ADDENDUM NO. 1

March 19, 2025

School District of Haverford Township | Coopertown Elementary School Renovations & Additions
CRA Project No. 3758

SITE PLAN	PROJECT 3758 C-103.1
PROJECT SCALE: AS SHOWN	
FILENAME:	
DATE: MARCH 10, 2025

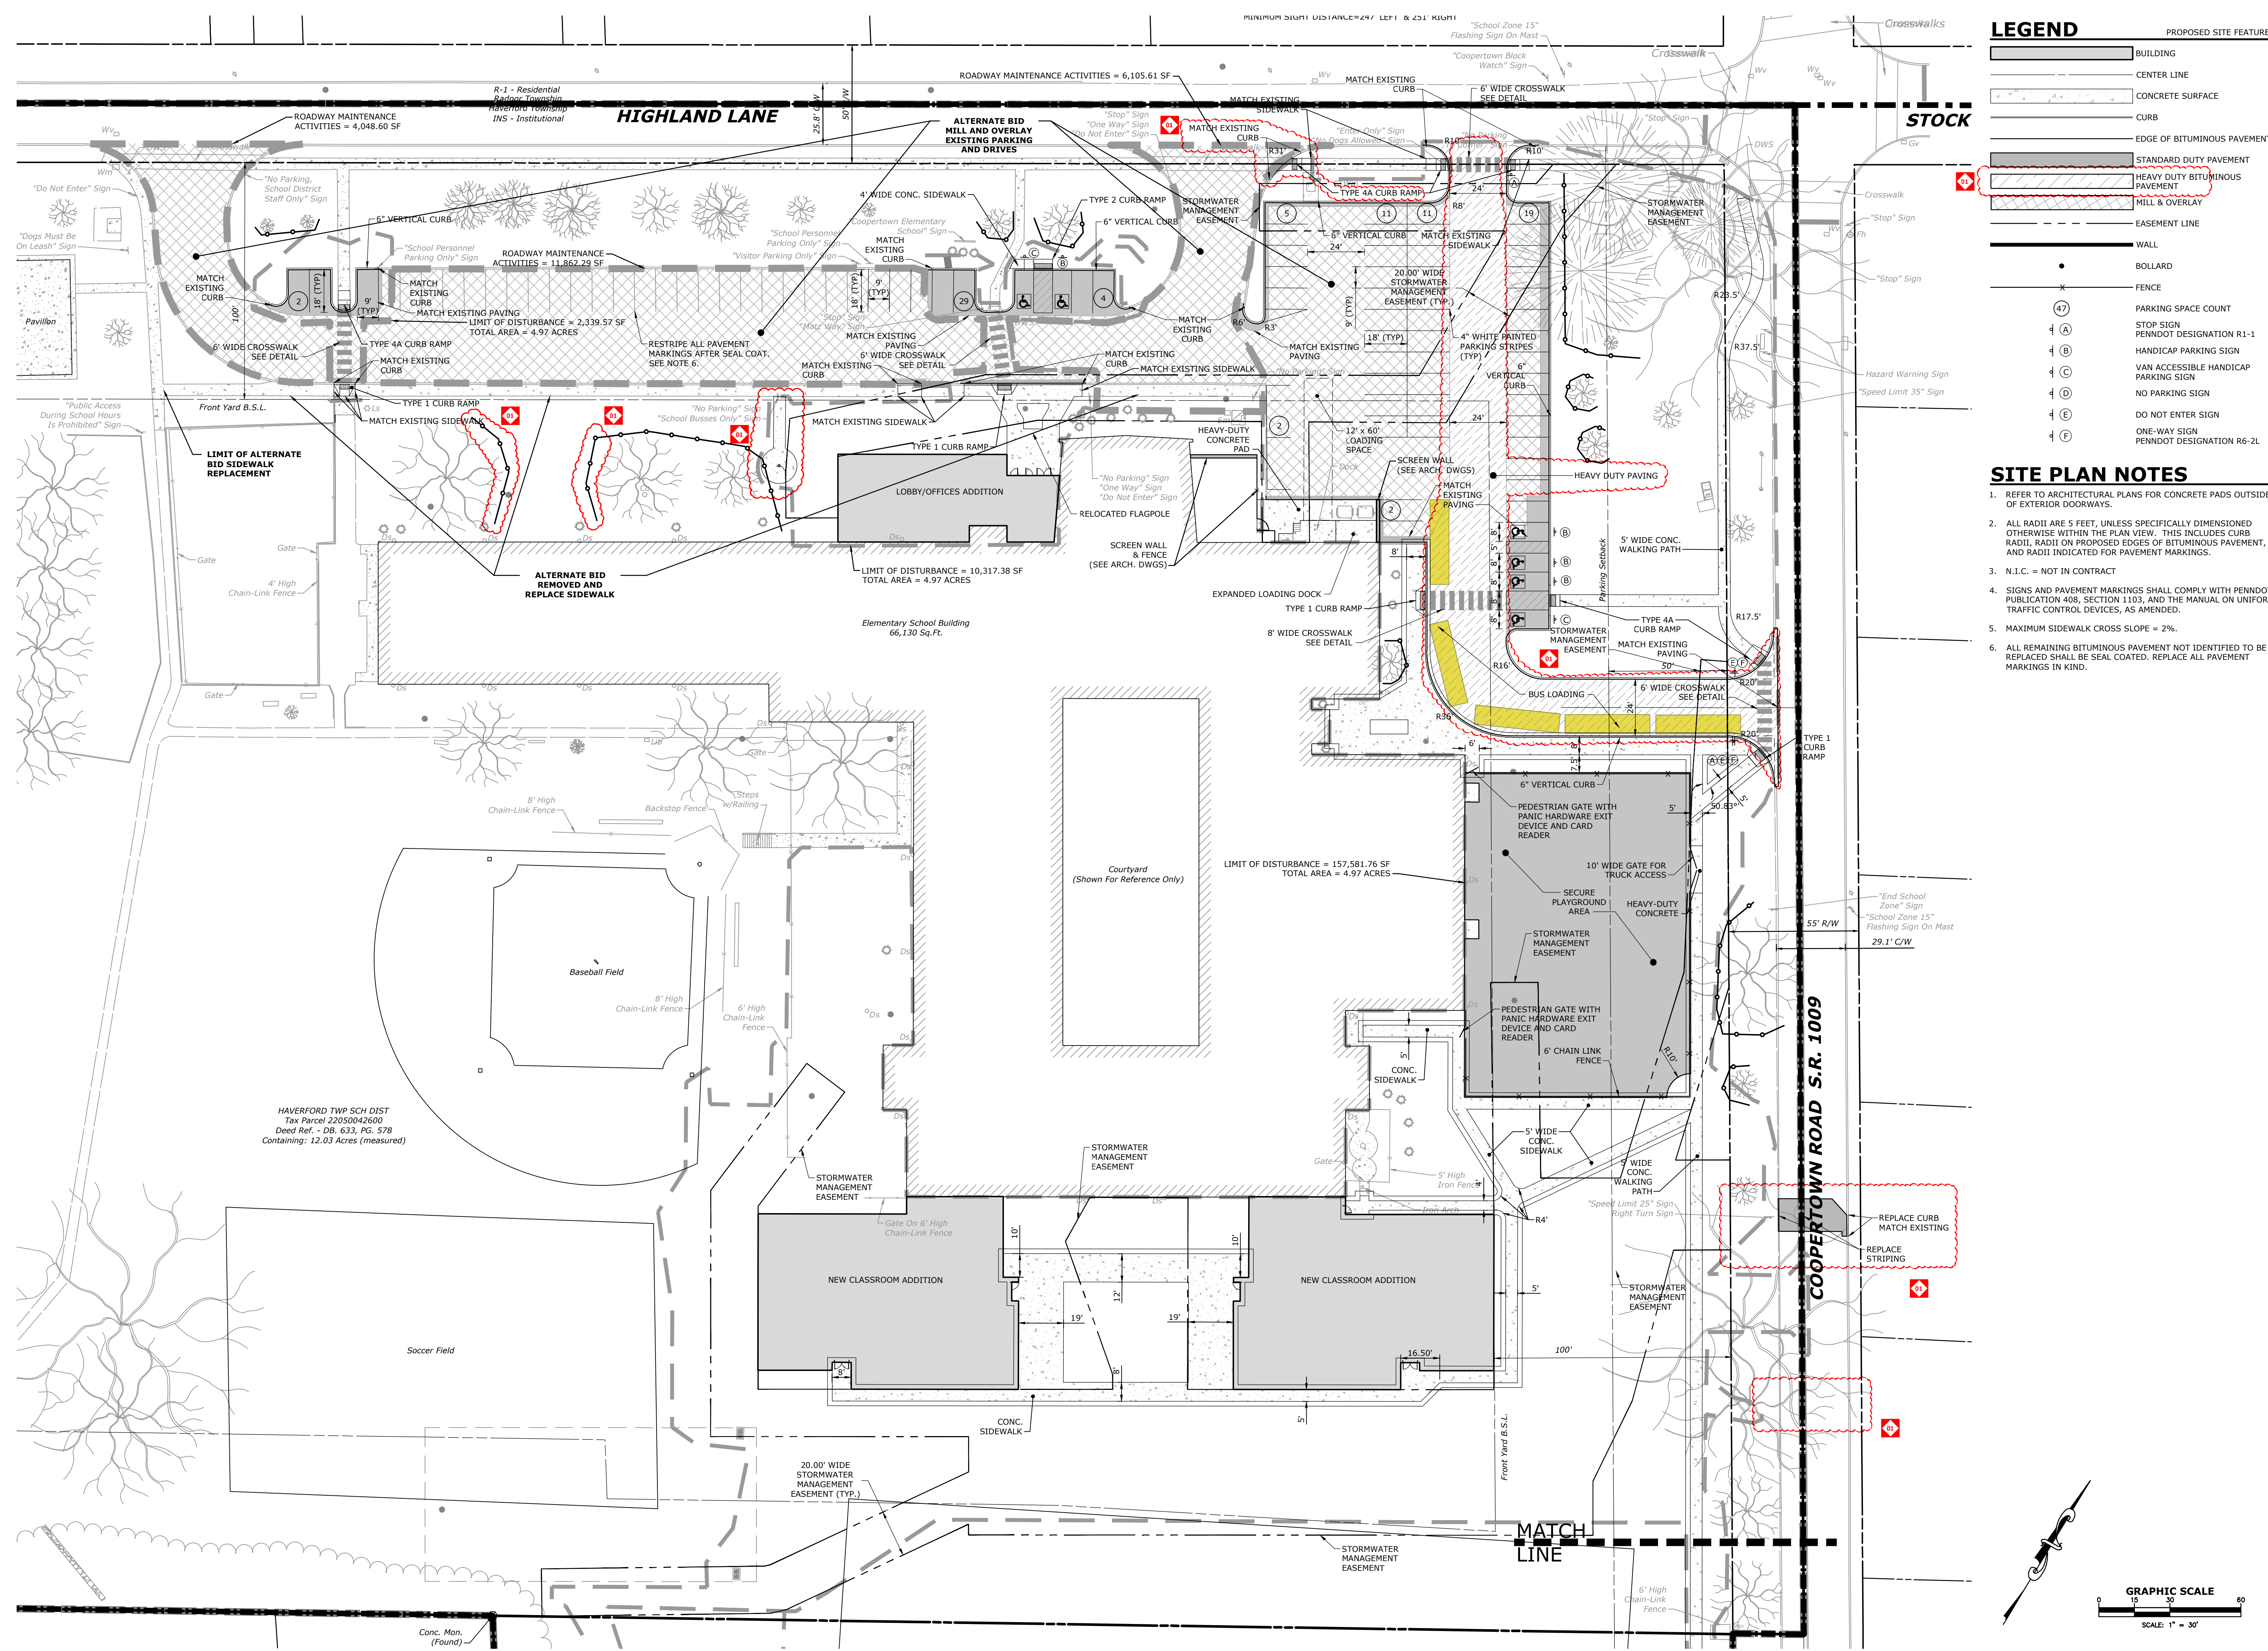
1. Heavy duty paving for bus lane.
2. Replace additional curb ramp.
3. Move sanitary sewer connection.
4. Revise Limits of Disturbance near flagpole
5. Add tree fence protection

C-103.2

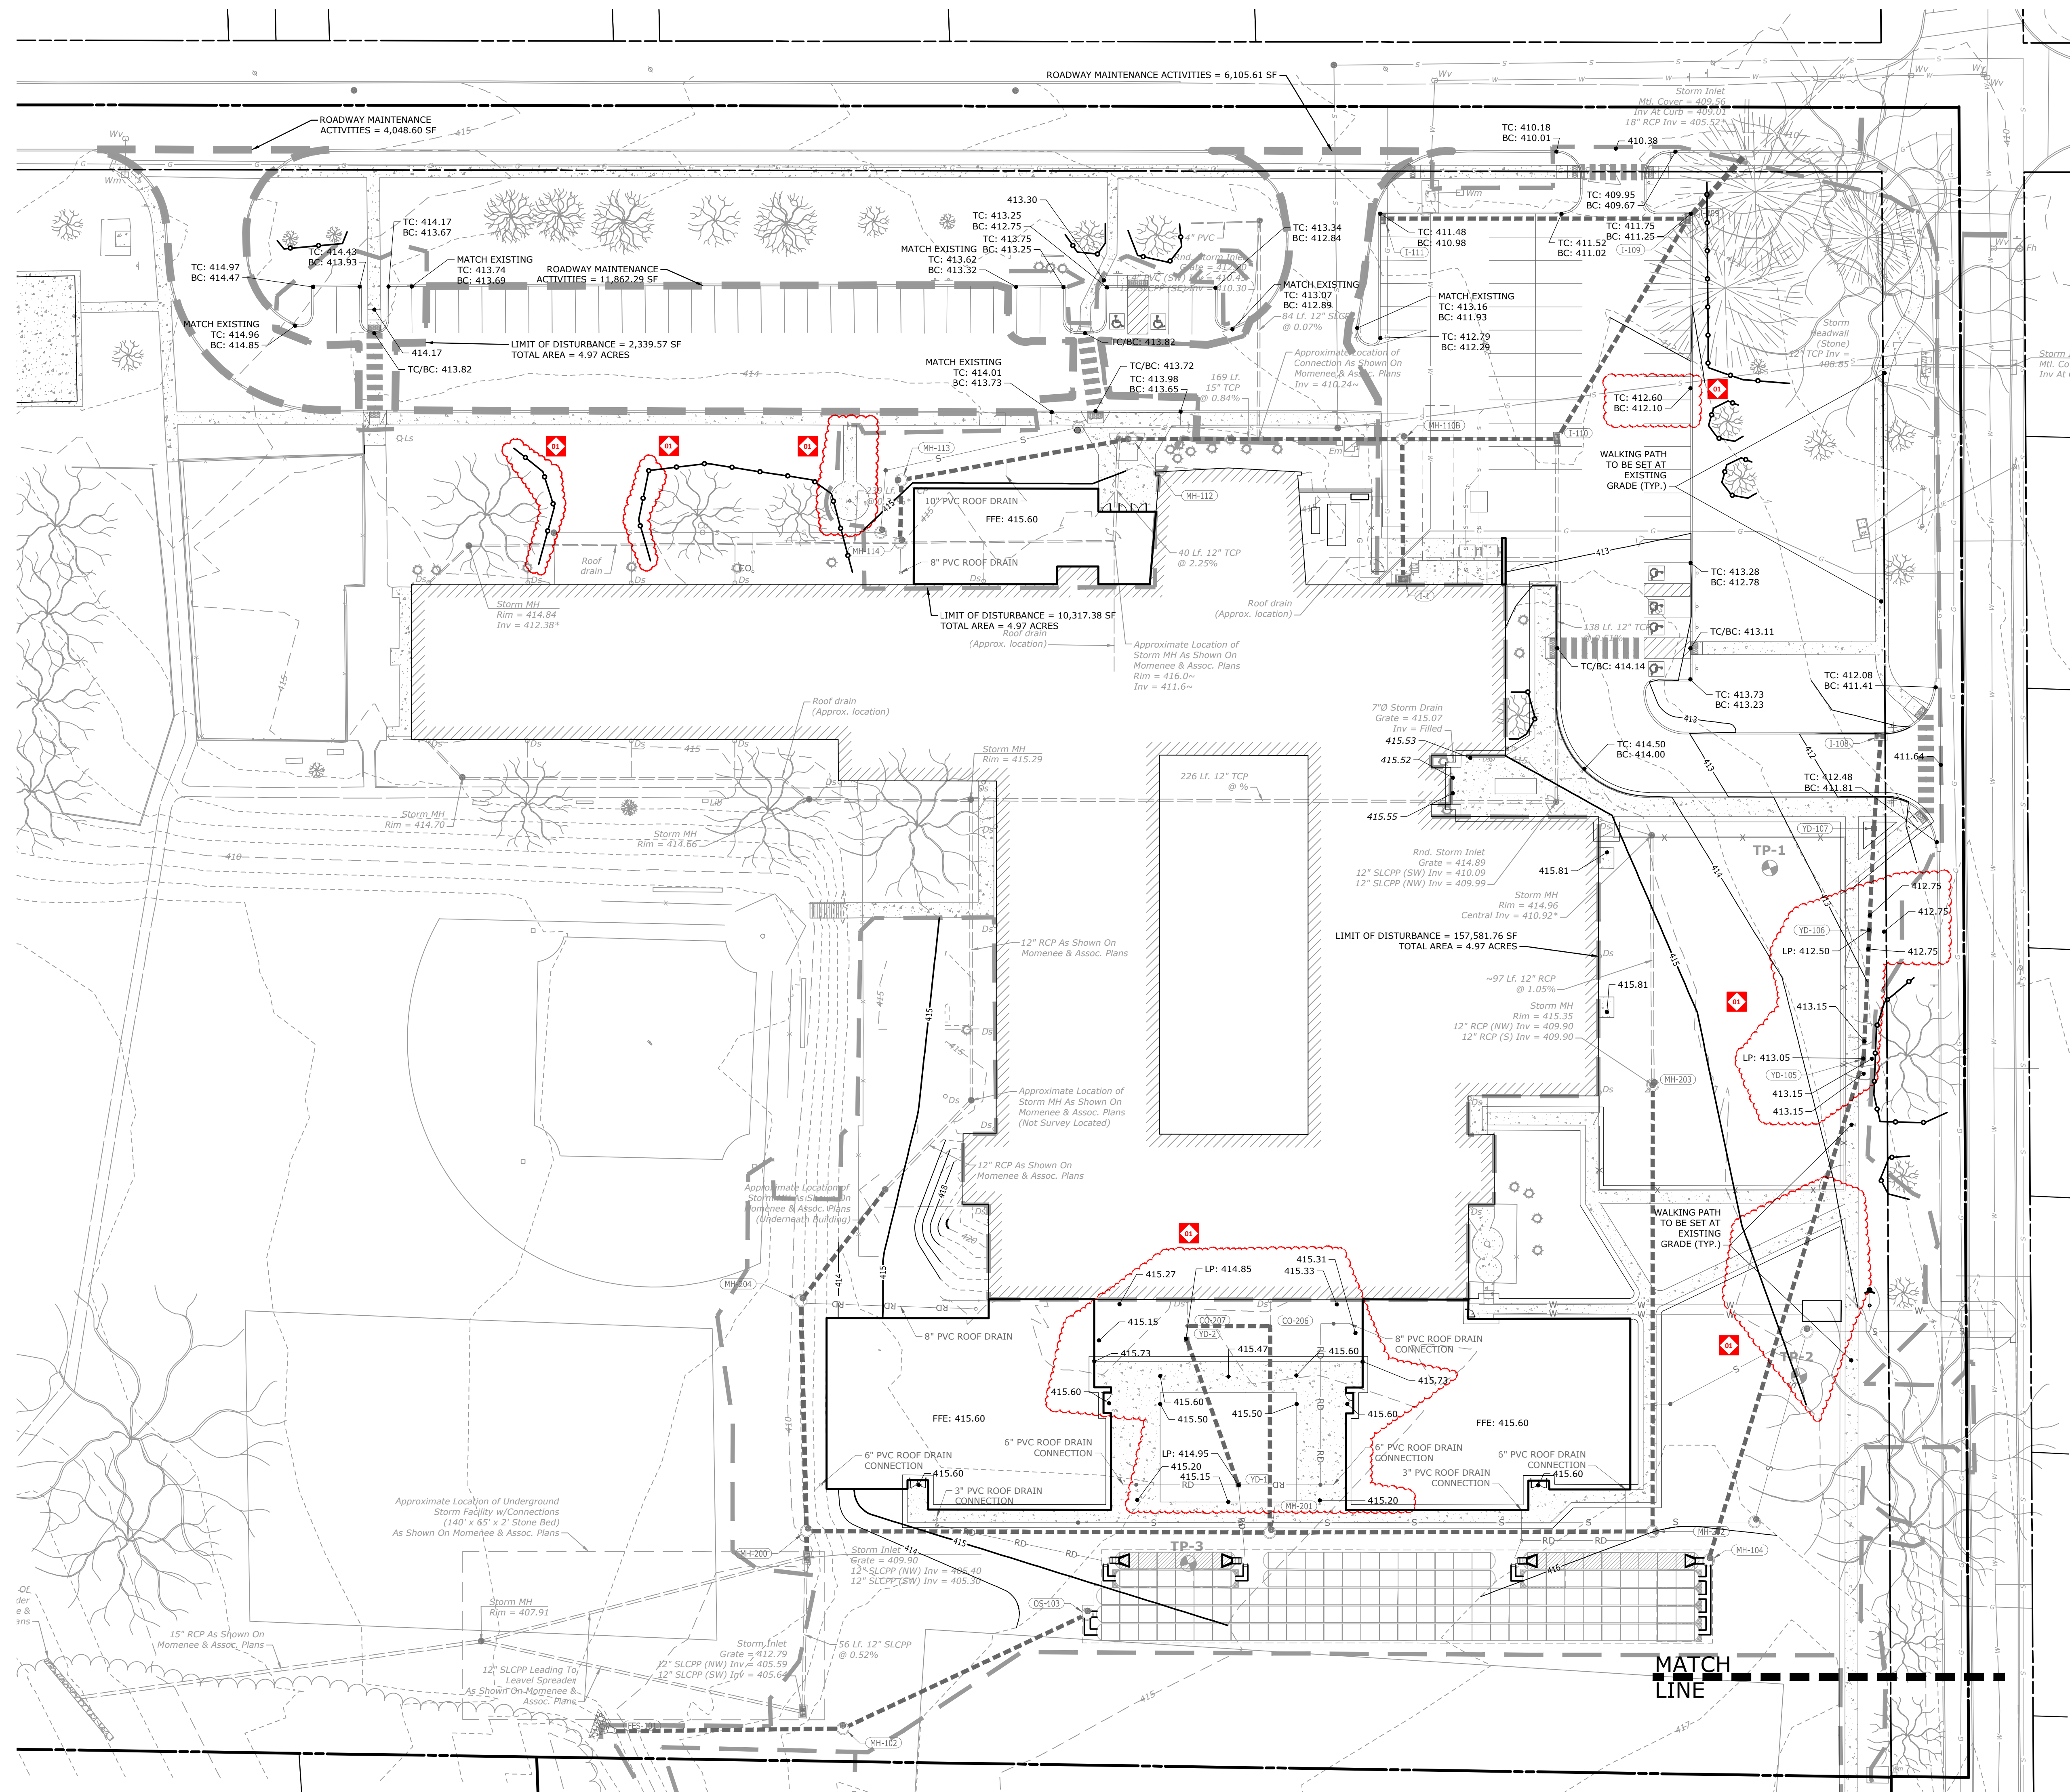
1. Revise Limits of Disturbance
